EMF-2103(NP)(A)
Revision 0

Realistic Large Break LOCA Methodology for Pressurized Water Reactors

EMF-2103(NP)
Revision 0

**Realistic Large Break LOCA Methodology for
Pressurized Water Reactors**

FLECHT-SEASET Test 31302

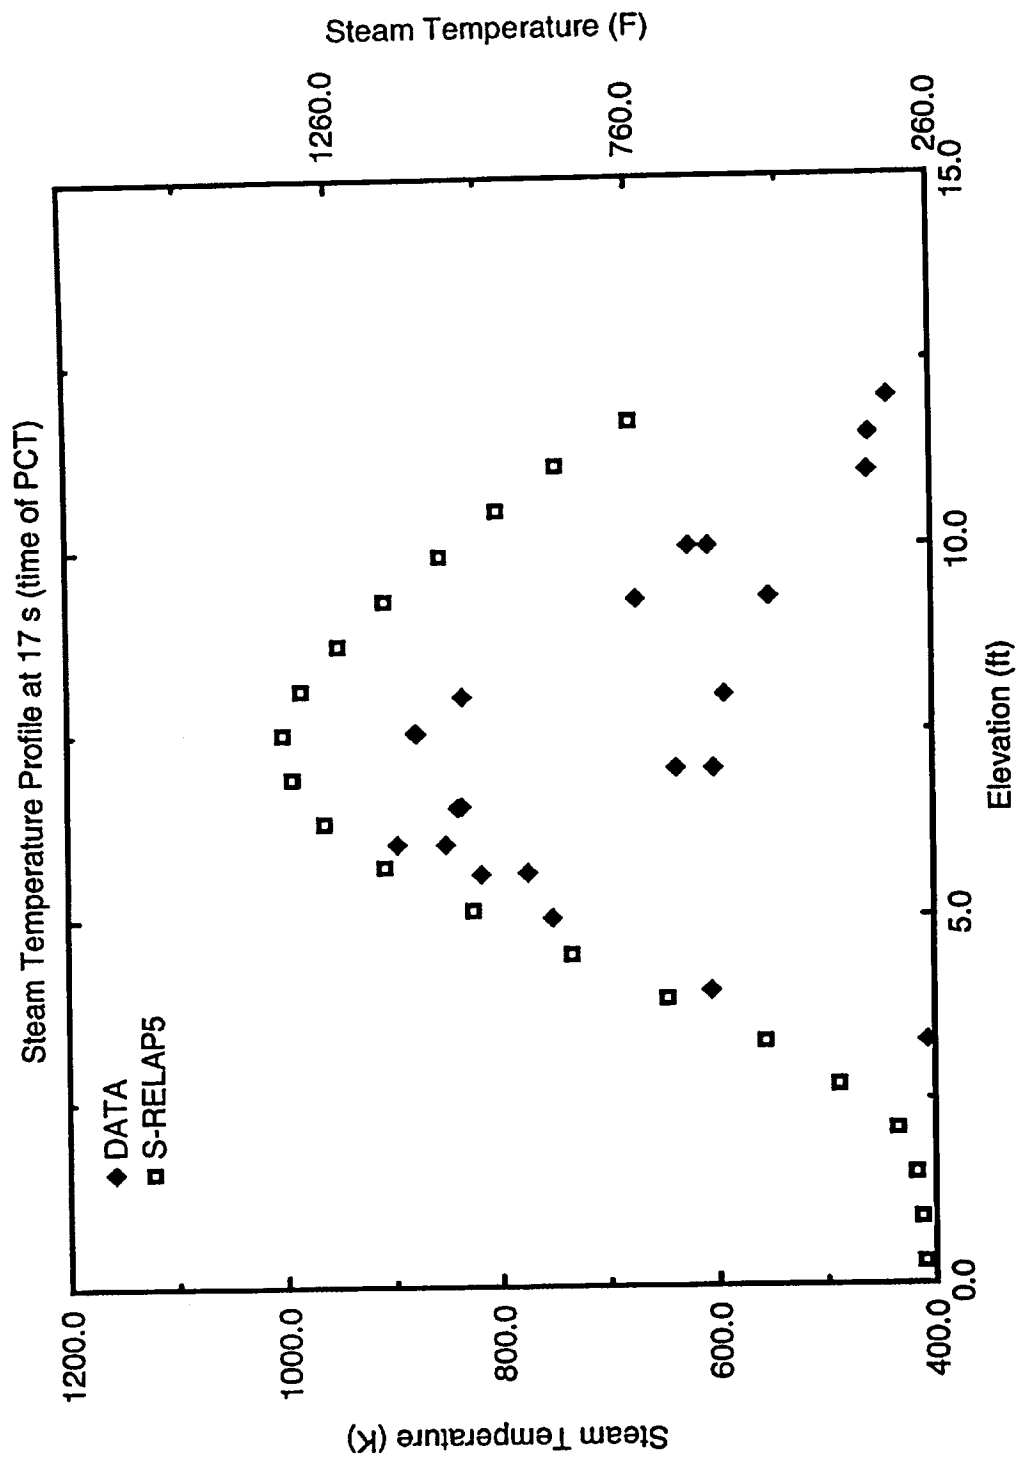
An overall comparison of the performance of the steam cooling model can be seen in Figure 1 (attached to this SE); the steam temperature at the time of PCT for FLECHT-SEASET Test 31302. The steam temperature predicted by S-RELAP5 is conservative relative to the measured steam temperature. The higher predicted steam temperature results in lower, conservative, heat transfer from the fuel rod simulators.

**Figure 4.35 Maximum Clad Temperature at All Measured Elevations,
FLECHT SEASET Test 31504**

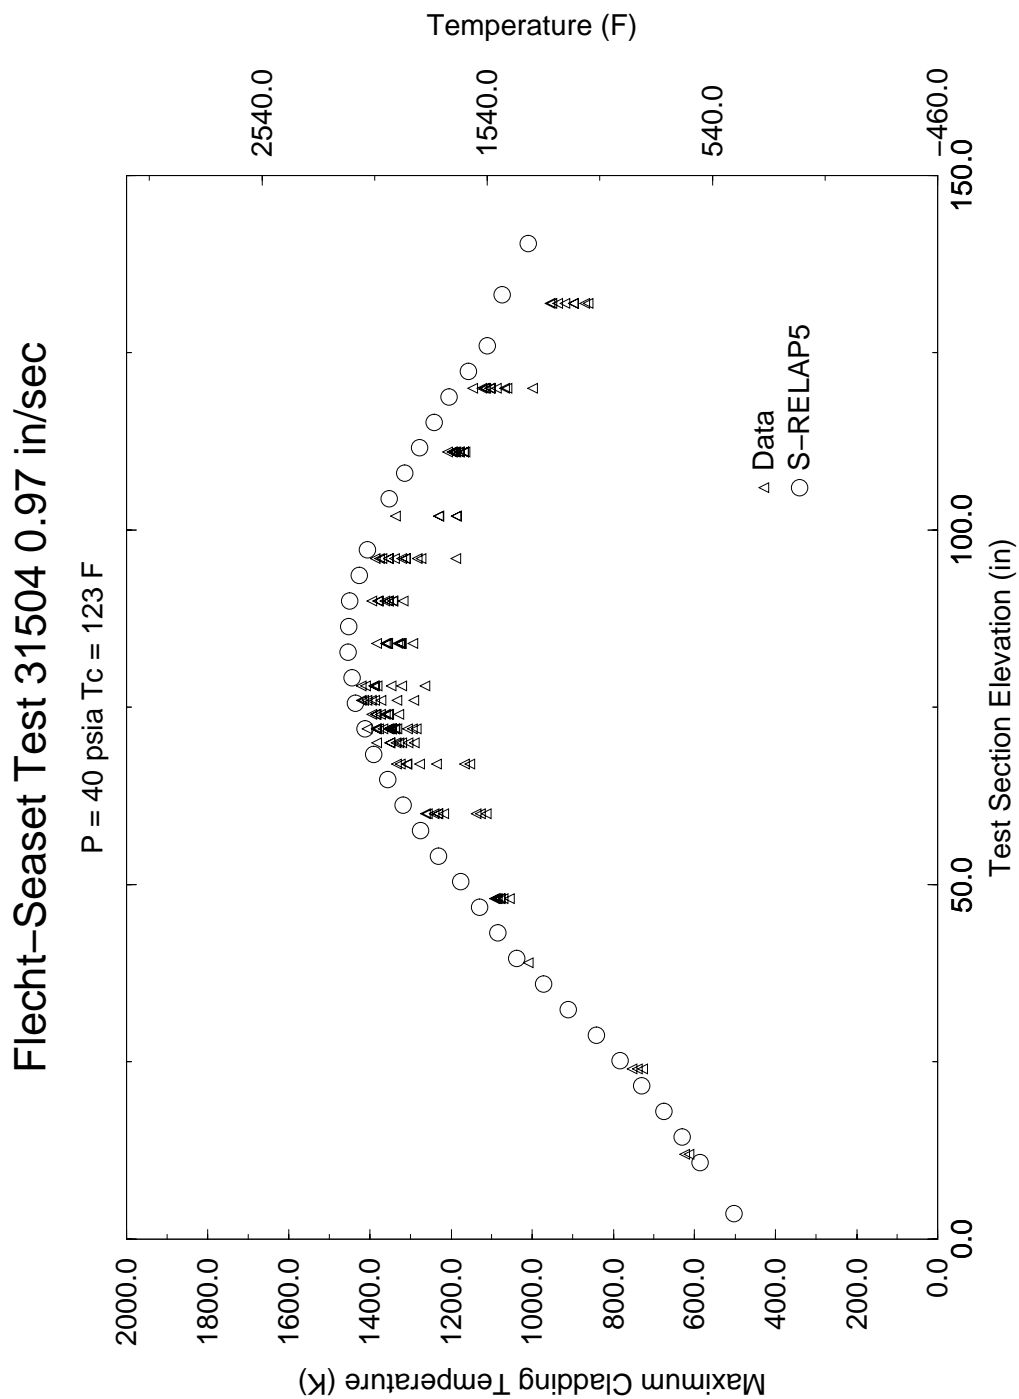
Before discussing the results of the review of the 2D/3D assessments, two examples are given of the assessments presented by Framatome ANP. Figure 2, Framatome ANP RLBLOCA Figure 4.35 taken from Reference 3, attached to this SE, shows the comparison of the S-RELAP5 maximum cladding temperature calculation versus the measured temperature for FLECHT-SEASET Test 31504. The figure shows that the code is conservative with respect to the measured cladding temperature throughout the length of the test assembly. Figure 3, Framatome ANP RLBLOCA Figure 4.194 taken from Reference 3, attached to this SE, shows the comparison between the S-RELAP5 predicted cladding temperature and the measured cladding temperature for LOFT test LP-LB-1. Two S-RELAP5 predictions are shown, one made without accounting for the code biases determined from the separate effects test assessments, and one made with the biases taken into account. Again, the code predicted cladding temperature is conservative relative to the measured temperature throughout the test assembly except at the very top of the fuel assembly. At that point, the temperature is significantly below the PCT. It is also noted in the LOFT assessment that the effect of considering the biases is to bring the code predicted temperature into close agreement with the measured temperature with the attendant data error bands.
